## Modification to run CPUxxCMI on 3MHz bus.

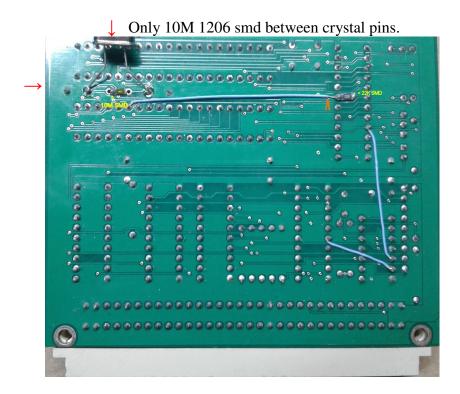
Replace xtal into 12MHz.
Replace C1 and C2 by 15 pF.
Place 10M 1206 smd between crystal pins.
Use the HD63C09, M68B09.
For the MC68B02. 22pF for C1 and C2, xtal 10MHz!

But for the HD63C09 add the Q clock for a better timing. See "Modification to run CPUxxCMI on 4MHz bus".
